ADDENDUM

Project Name:	Project Name: New Gymnasium	Addendum No.:	Three (3)
	Owner's Name: Grady ISD	Date:	01/09/09
	Street Address: 3500 FM 829.	Project No.:	07031.2
	City, State Zip: Lenorah, Texas 79749

STRUCTURAL ADDENDUM NO. 3

PROJECT NO. 07031.2	PROJECT: GRADY HIGH SCHOOL GYM ADDITION GRADY ISD	LENORAH, TEXAS	DATE: 01/6/09 SCALE: NOTED
THOMA ENGINEERING, INC.		5502 58th, SUITE 200 LUBBOCK, TEXAS 79414-2074 (806) 745-4881	DRAWING NO. SA#3-1

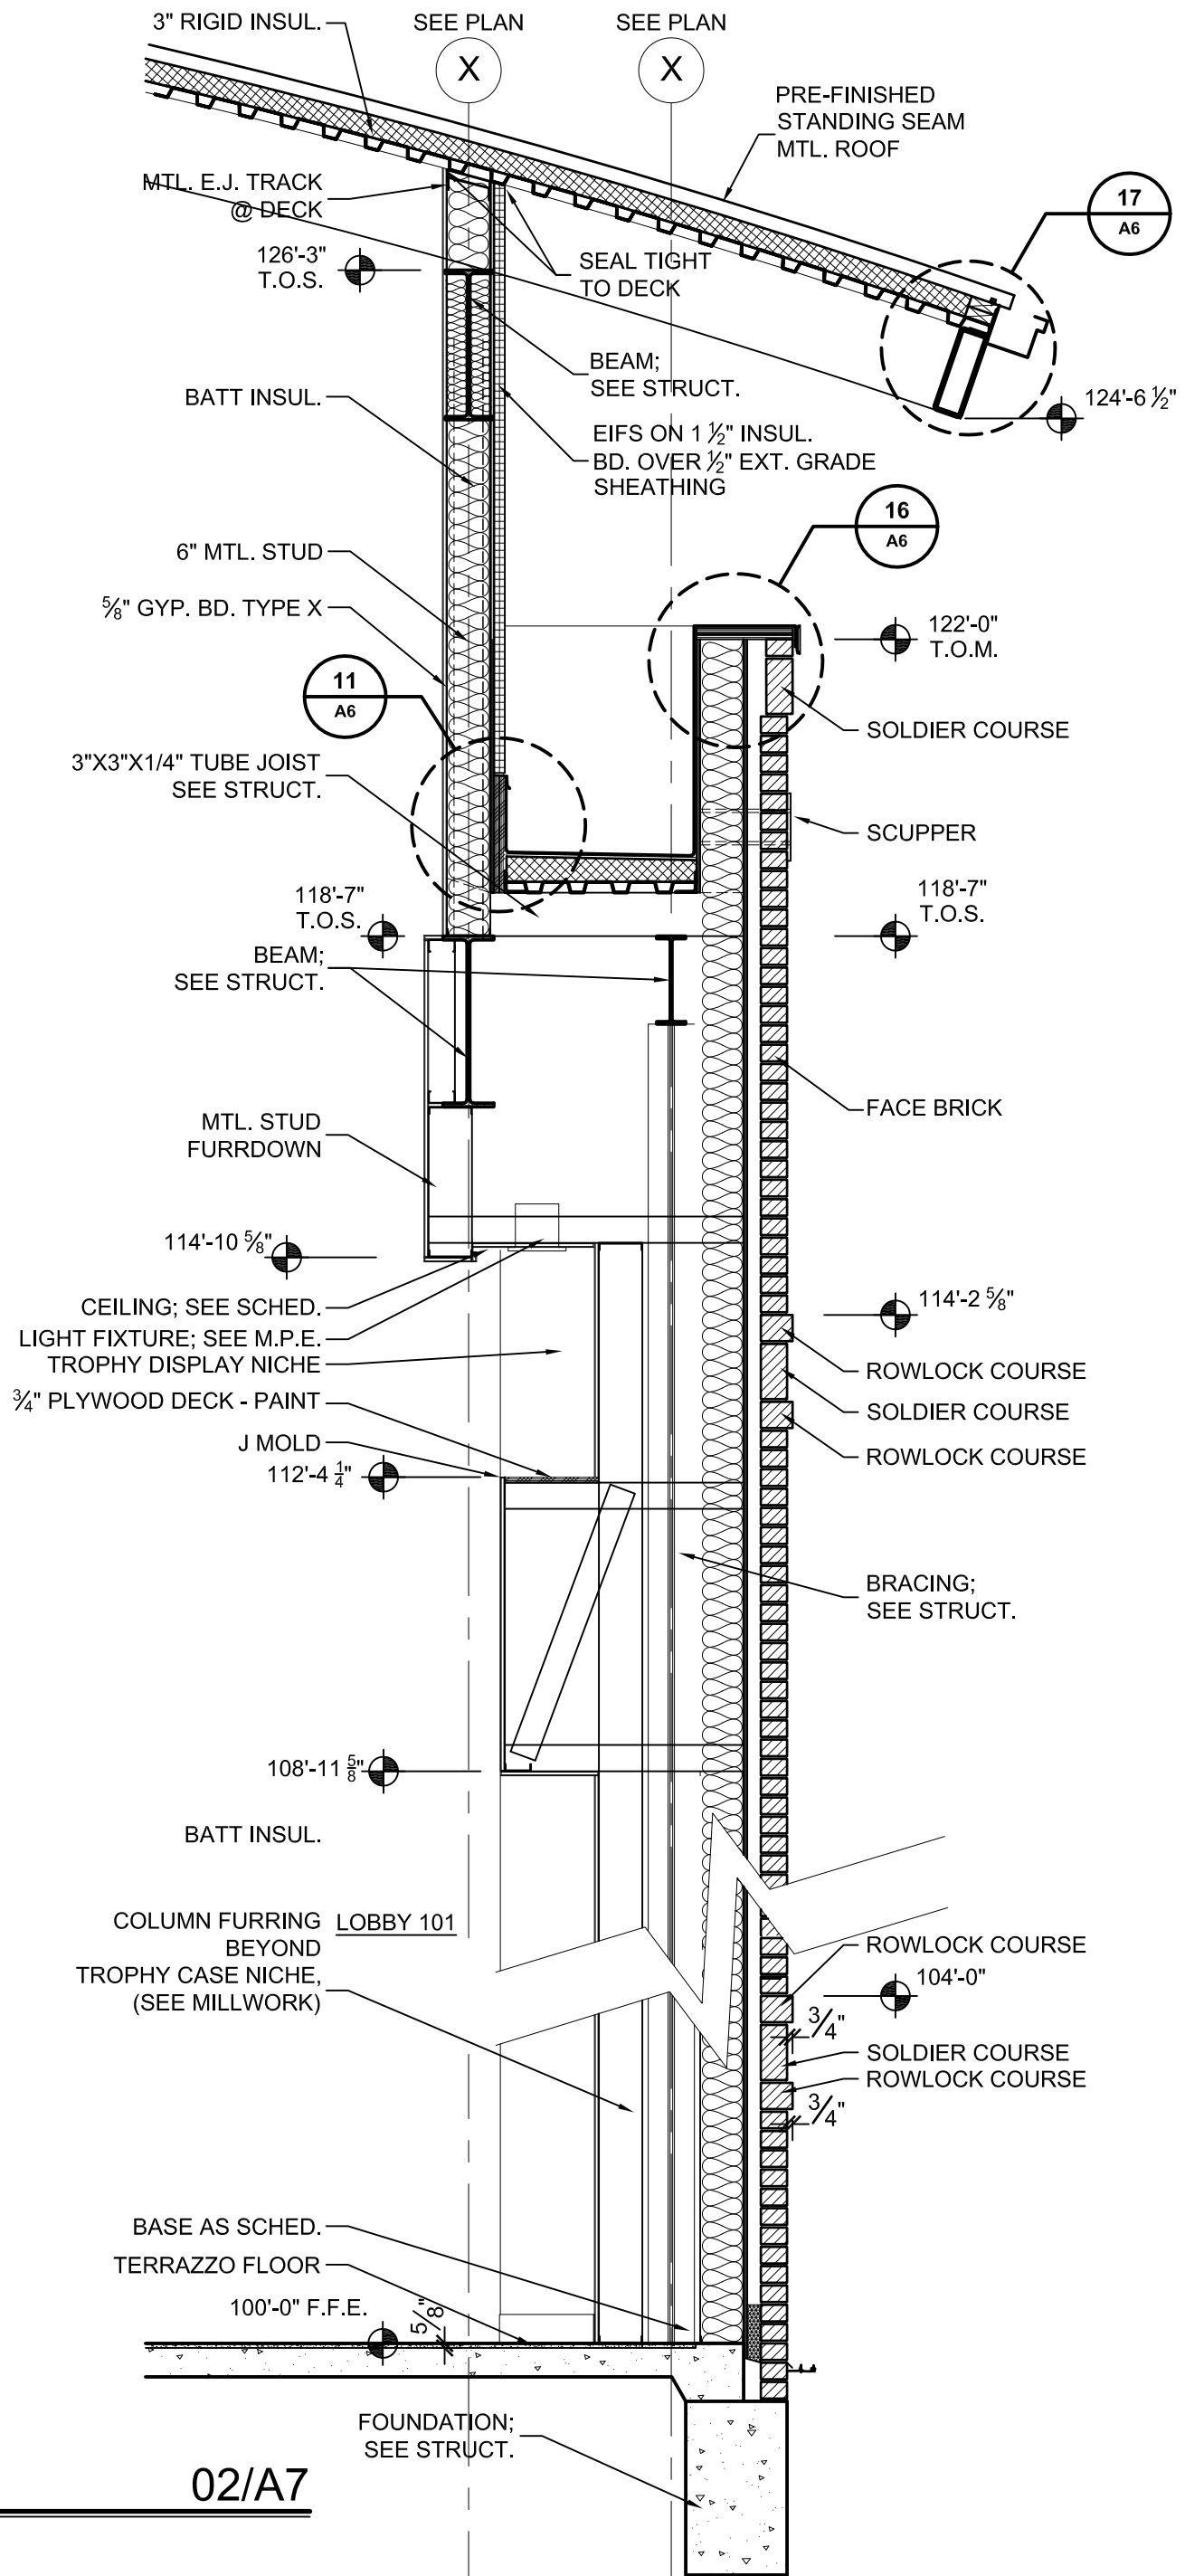
- Item No. Five:** In the Drawings, Sheet S13, for clarification purposes add Knee Brace Detail 10/S13 as shown in SA#3-1 attached herewith.
- Item No. Six:** In the Drawings, Sheet A7, for clarification purposes replace section 02/A7 with SD-19 attached herewith.

10 KNEE BRACE DETAIL
S13 SCALE: 1" = 1'-0"
